Preliminary Consultation
MONTGOMERY COUNTY HISTORIC PRESERVATION COMMISSION
STAFF REPORT

Address:	12 E. Lenox St., Chevy Chase	Meeting Date:	3/27/2019
Resource:	Contributing Resource Chevy Chase Village Historic District	Report Date:	3/20/2019
Applicant:	Justin and Elizabeth Bausch (Ben Van Dusen, Architect)	Public Notice:	3/13/2019
Review:	Preliminary Consultation	Staff:	Dan Bruechert
PROPOSAL:	Building Additions and Swimming Pool Construction

Figure 5: Detail of 1927 Sanborn map showing the reconfigured full-width front porch.

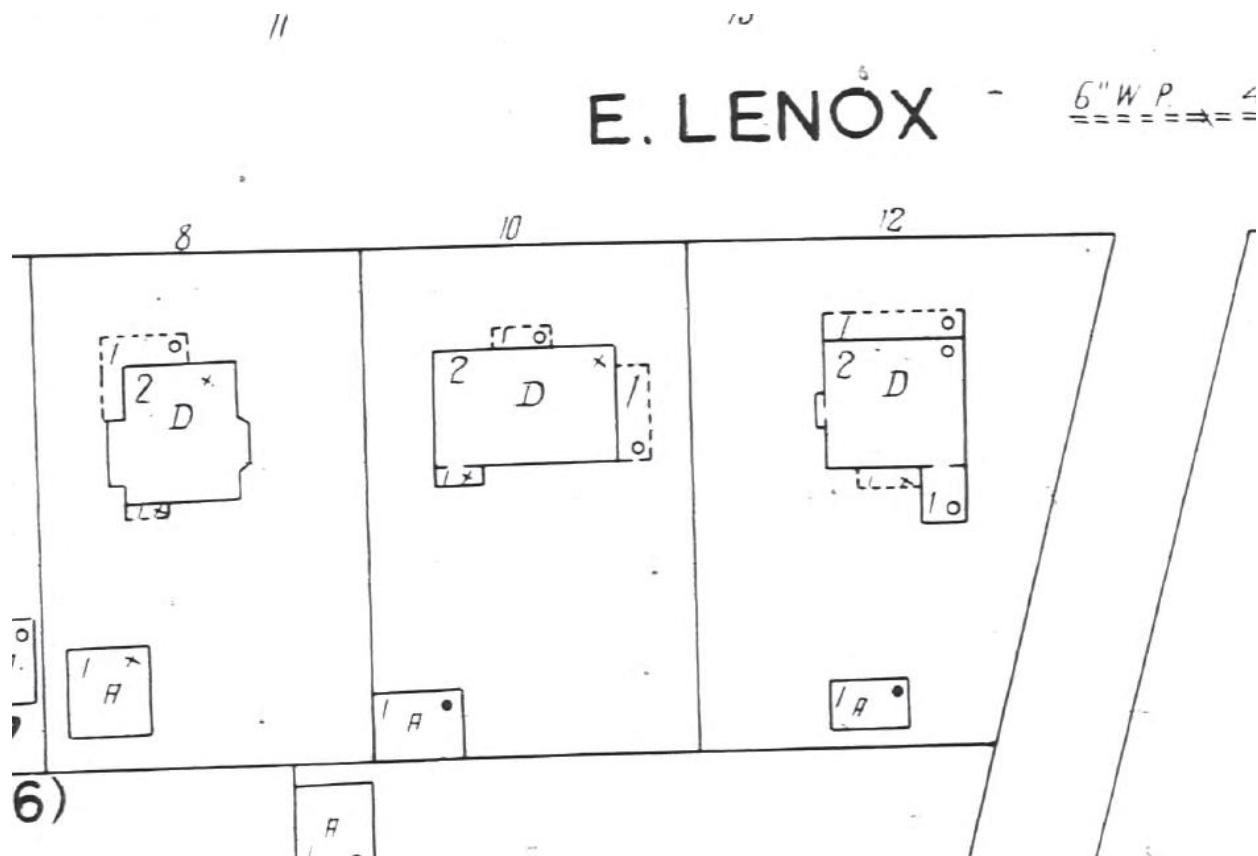
The applicant proposes removing the front steps and rehabilitating the front porch. The existing steps are wood, and the applicant has indicated that they do not meet current code. The applicant proposes a new set of code-compliant steps that will project an additional 1' (one foot) into the front yard. The applicant proposes to construct the stairs with brick cheek walls and bluestone treads and risers. The cheek wall will match the historic house foundation and brick piers supporting the front porch (the historic photographs show a continuous brick wall under the historic porch). In reviewing Sanborn maps, Staff has found evidence that the porch was reconfigured sometime before 1927.

Figure 6: Historic photo showing the front porch in its historic configuration.

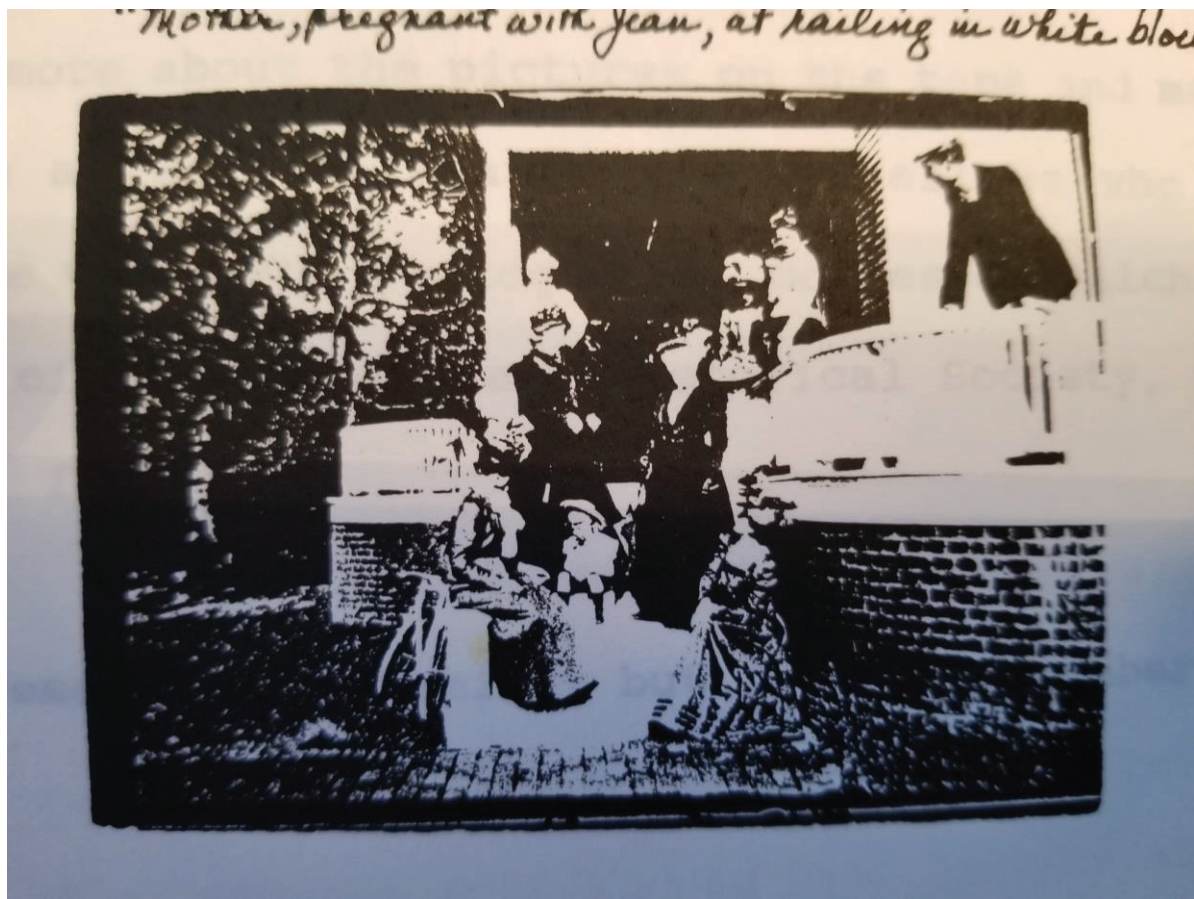
The other alterations proposed for the porch, i.e. the balusters, columns, etc. are not a restoration of the historic porch configuration. The applicant is not proposing to reintroduce the half-round porch projection or bring back the square column bases with what appears to be highly decorative scrolls or the finials in the porch corners. Staff finds that the proposal is consistent in part with the building's existing design, even though it does not replicate its architectural style or historic appearance. It does, however, approximate the massing of the roof for the front porch and will visually balance the lower and upper sections of the porch.

The changes to the columns; however, do not have a basis in the historical photographs. It seems that the existing condition with the finely tapered columns on wooden piers date from an earlier configuration and are more similar to the condition that existed in the historic photographs. The columns and piers should remain in this configuration, and the other alterations can be supported. Staff would recommend approval for the porch alterations, save the new, longer, columns, at the HAWP stage.

Proposed North (Front) Elevation

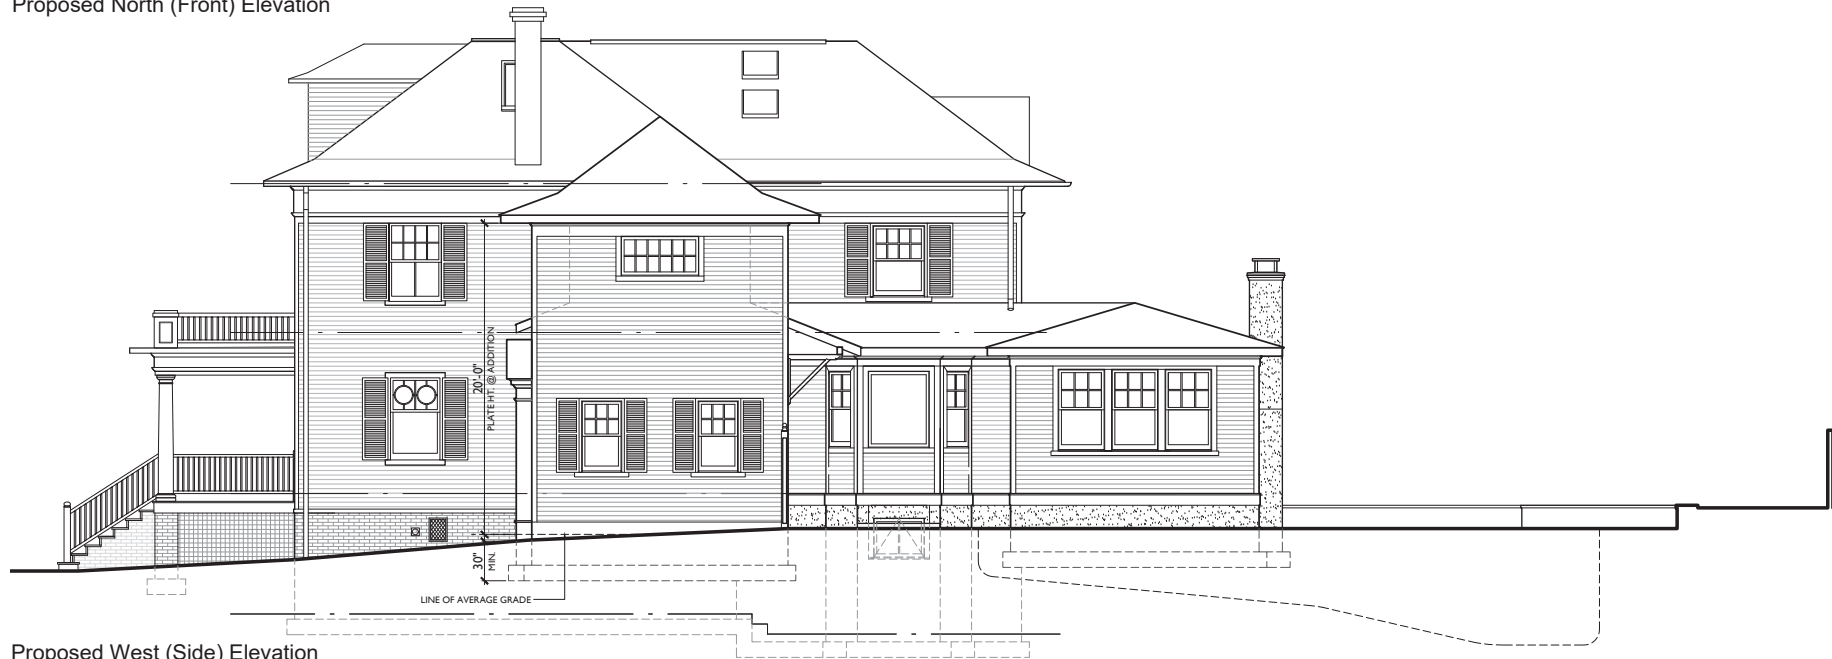
The architectural details of the side addition are similar to the historic house with wood siding, trim, and shutters to match, six-over-two and six-over-one wood windows and a reinstalled decorative leaded glass transom panel. The eave line and roof line of the addition will sit below roof and eave of the historic house (see fig. 3 below).

Staff finds that some west side construction can be supported under the *Guidelines* and as compatible in character with the surrounding district (24A-8(b)(2)). The provisions for ‘*major additions*’ state, “Major additions which substantially alter or obscure the front of the structure should be discouraged but not automatically prohibited. For example, where lot size does not permit placement to the rear, and the proposed addition is compatible with the street scape, it should be subject to moderate scrutiny for contributing resources.” However, Staff finds that the proposed addition is too wide and too massive to be compatible with the historic house or surrounding streetscape. The proposed side addition is 26’ 2” (twenty-six feet, two inches) wide and set back 15’ 3” (fifteen feet, three inches) from the front wall plane. The exact width of the historic house was not provided in the application materials, but it appears to be approximately 30’ (thirty feet) wide. Conservatively, this will widen the house by 75%. While the house does have some side projections in the form of the bay windows to the west (right) and the larger overhang to the east (left), an addition of this size and scale would significantly disrupt the general balance of the house. Staff has additional concerns about the increase in lot coverage. Alterations of lot coverage are to be subject to strict scrutiny with regard to preserving the District’s open, park-like setting; and while the proposed lot coverage is significantly less than maximum allowed by code, the reduction of the side yard will impact that setting.

Staff requests the HPC’s input regarding the appropriateness of any side-projecting addition to the historic resource.
